Work Order ID 94358

Item Name: Crosstube Turning Detail

DART AEROSPACE LTD	Work Order:	94358
Description: Crosstube Assembly (412 Low Aft)	Part Number:	D412-664-249
Inspection Dwg: D412-664-249 Rev: B		Page 1 of 2

DRAWING NO. D412-664-249	TITLE CROSSTUBE ASS'Y (412 LOW AFT)	REV. B	DART AEROSPACE LTD ENGINEERING ORDER		D.E.O. NO. D412-664-249-B-1	SHEET NO. SHEET 1 OF 2	SCALE NTS
DRAWN 97	CHECKED SC	MFG. APPR. R	APPROVED MD		DE APPR. H		
DATE 11.05.25	DATE 11.05.31	DATE 11.05.31	DATE 11/05/31		DATE 11.05.31

D412-664-249
ASSEMBLY DETAIL

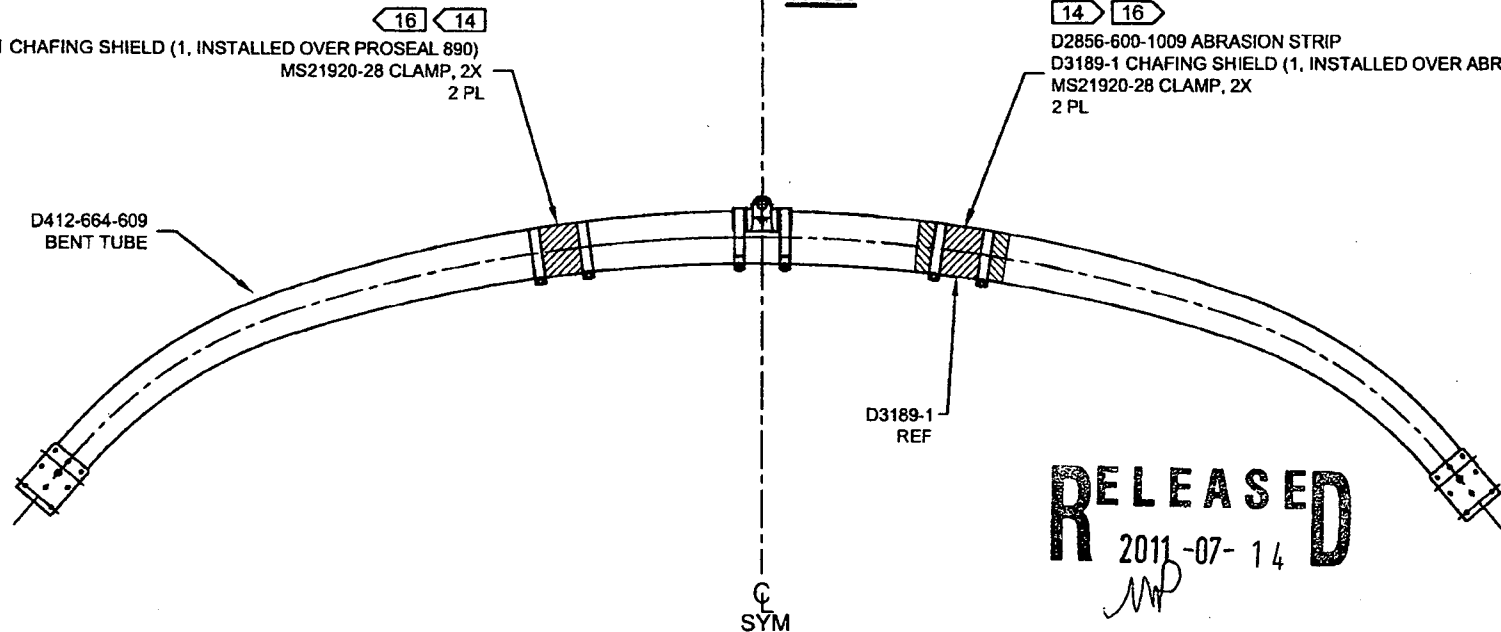
REMOVED ABRASION STRIP IN FAVOR OF A THIN LAYER OF PROSEAL 890.

NOTE 14, SHEET 1 IS AMENDED AS FOLLOWS:

- 14) INSTALL D2856-600-1009 ABRASION STRIPS WITH A 0.13 REF GAP ON BOTTOM SIDE OF CROSSTUBE PER QSI 035.

WAS:

D2856-600-1009 ABRASION STRIP
D3189-1 CHAFING SHIELD (1, INSTALLED OVER ABRASION STRIP)
MS21920-28 CLAMP, 2X
2 PL

- 14) APPLY A THIN COAT OF PROSEAL 890 ON INSIDE CONCAVE SURFACE OF D3189-1 CHAFING SHIELD AND LET CURE PER MANUFACTURER'S INSTRUCTIONS. INSTALL PROSEALED D3189-1 CHAFING SHIELD ONTO CROSSTUBE BY APPLYING A THIN COAT OF PROSEAL 890 ONTO CROSSTUBE. BE SURE TO ELIMINATE ANY AIR GAPS.

IS:

D3189-1 CHAFING SHIELD (1, INSTALLED OVER PROSEAL 890)
MS21920-28 CLAMP, 2X
2 PL

**D412-664-249
ASSEMBLY DETAIL**

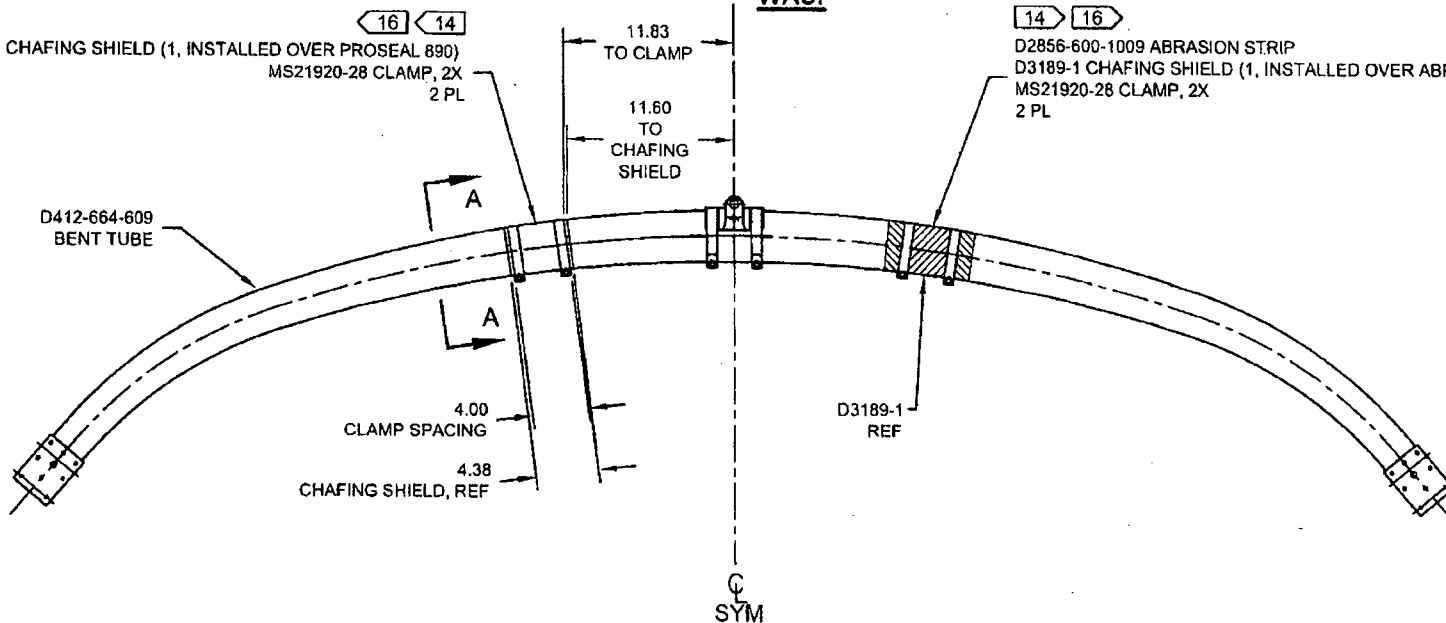
REMOVED ABRASION STRIP IN FAVOR OF A THIN LAYER OF PROSEAL 890. UPDATE INSTALLATION OF CHAFING SHIELDS AND REDUCE TORQUE TO 40-50 IN-LBS. THIS ENGINEERING ORDER SUPERCEDES DEO D412-664-249-B-1

WAS:

D2856-600-1009 ABRASION STRIP
D3189-1 CHAFING SHIELD (1, INSTALLED OVER ABRASION STRIP)
MS21920-28 CLAMP, 2X
2 PL

IS:

D3189-1 CHAFING SHIELD (1, INSTALLED OVER PROSEAL 890)
MS21920-28 CLAMP, 2X
2 PL
